# PERMIT

SEWAGE DISPOSAL SYSTEM

SUBDIVISION ROAD 7540 Washington Blvd.

PROPERTY OWNER Luskin's

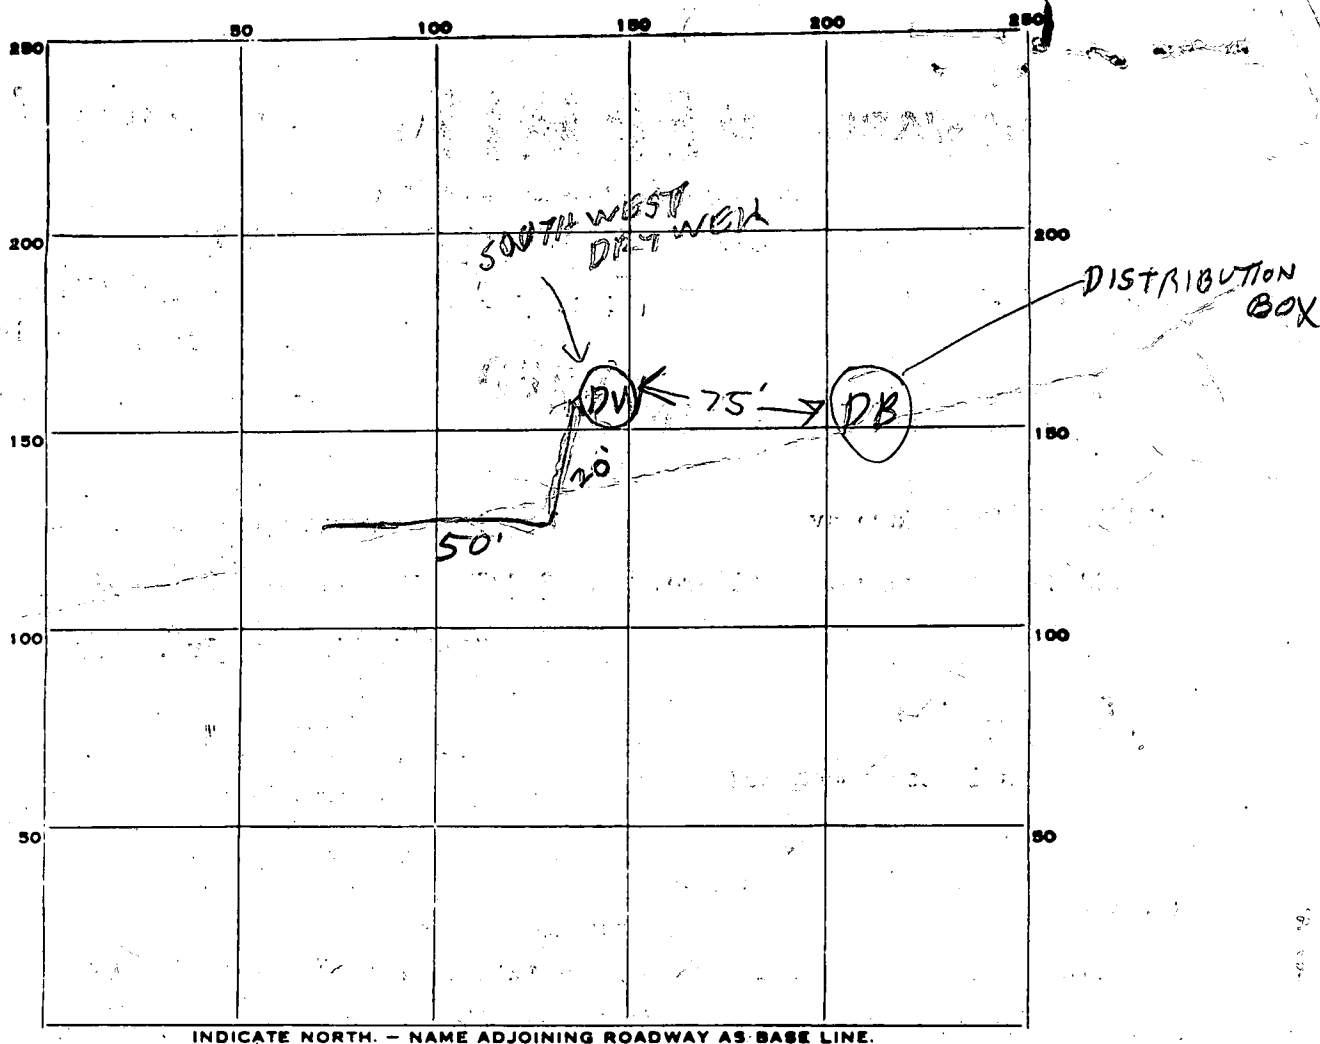
6/18/79 - BOY PHILLIPS SAID

FF & DM WERE HERE TWO WEEKS AGO & RECOMMEND SHALLOW BED  
OFF OLD DRY WELL

REMARKS 6/18/79 - DITCH OFF OLD DN ONE PART 20 FT  
LONG 2 FT WIDE & THE OTHER 50 FT LONG 7 FT WIDE  
DITCH IS 3 1/2 FT DEEP PER MR PHILLIPS MR. PHILLIPS  
IS USING RED ROSEN PAPER BUT NO PIPE IN DITCH CALLED DN  
HE SAID EVERYTHING OK EXCEPT 70 FT OF PERFORATED PIPE  
NEEDED TO RUN THROUGH DITCH R/L

Final acceptance of the Luskin's (Permit No. 29888) septic system addition is herewith given in spite of the fact it was installed deeper than originally instructed and the distribution pipe was connected to a gravel ditch not the dry well as instructed.
